## HISTORIC AND DESIGN REVIEW COMMISSION

October 02, 2019

**HDRC CASE NO:** 2019-478  
**ADDRESS:** 317 WICKES  
**LEGAL DESCRIPTION:** NCB 939 BLK 2 LOT 5  
**ZONING:** RM-4, H  
**CITY COUNCIL DIST.:** 1  
**DISTRICT:** King William Historic District  
**APPLICANT:** Roger and Ruth Williamson/WILLIAMSON FAMILY PROTECTION TRUST  
**OWNER:** WILLIAMSON FAMILY PROTECTION TRUST  
**TYPE OF WORK:** Driveway; carport; landscaping  
**APPLICATION RECEIVED:** August 15, 2019  
**60-DAY REVIEW:** October 14, 2019  
**CASE MANAGER:** Huy Pham

# 317 Wickes

FLOOR PLAN

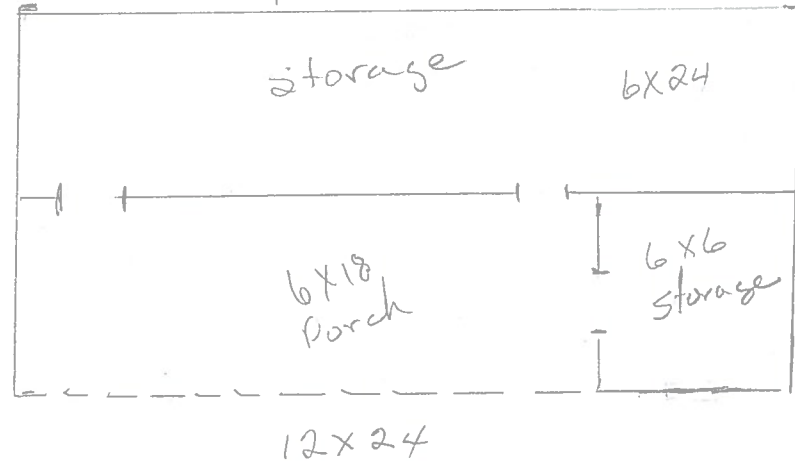
- c. **ACCESSORY STRUCTURE** – The applicant has proposed to construct a rear accessory structure to replace the existing metal shed. The proposed structure is to feature twelve feet in depth deep, twenty-four feet in width, and fourteen feet in height for an overall size of 288 square feet. The applicant has proposed for the structure to feature wood lap siding (117 profile), a corrugated metal roof, an inset porch with a door and no windows.

- h. **ACCESSORY SETBACK AND ORIENTATION** – By proposing to locate the structure in the rear corner facing the interior of the rear yard, staff finds that proposed orientation and setback is generally consistent with the Guidelines for New Construction 5.B.i and ii. The applicant must comply with all setback requirements as required by Zoning and obtains a variance from the Board of Adjustment, if applicable.

# Front Elevation - Proposed

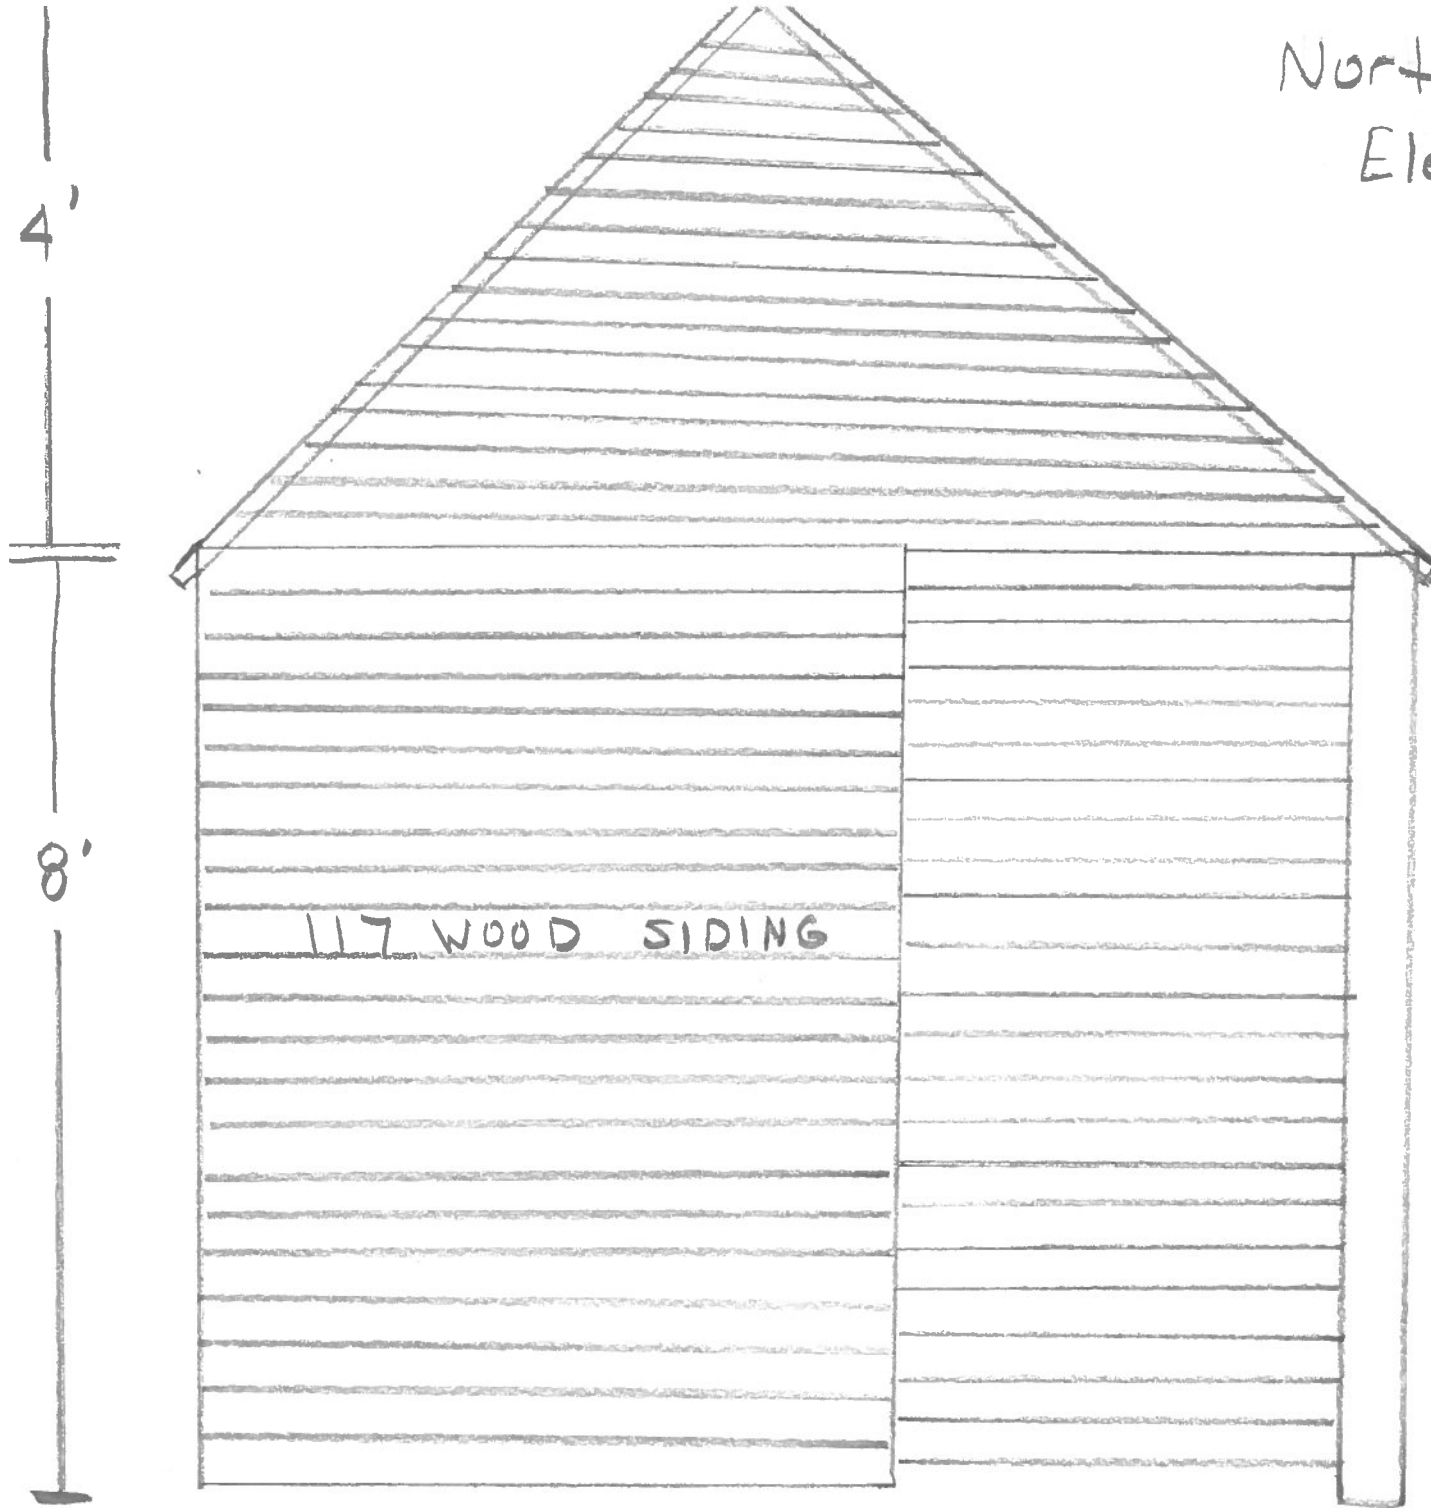
- g. **ACCESSORY FENESTRATION** - Per the Guidelines for New Construction 5.A.iv., window and door openings should be designed to be similar to those found on historic garages or outbuildings in the district or on the principle historic structure in terms of their spacing and proportions. Staff finds that the proposed fenestration to only include a door is inconsistent with the Guidelines. The applicant should incorporate wood sash windows flanking the proposed door to relate to the primary historic structure and to provide egress.

- i. The proposed rear accessory structure feature fenestration patterns that relate to primary historic structure. Staff recommends including at least one wood sash window. The final design shall be submitted to staff for review and approval prior to installation.
- ii. That the applicant comply with all setback requirements as required by Zoning and obtains a variance from the Board of Adjustment, if applicable.
- iii. That the proposed privacy fence feature no than six (6) feet in height.
- iv. That the driveway is limited to ten (10) 10 feet in width and does not encroach into the neighboring property at the narrow side yard.
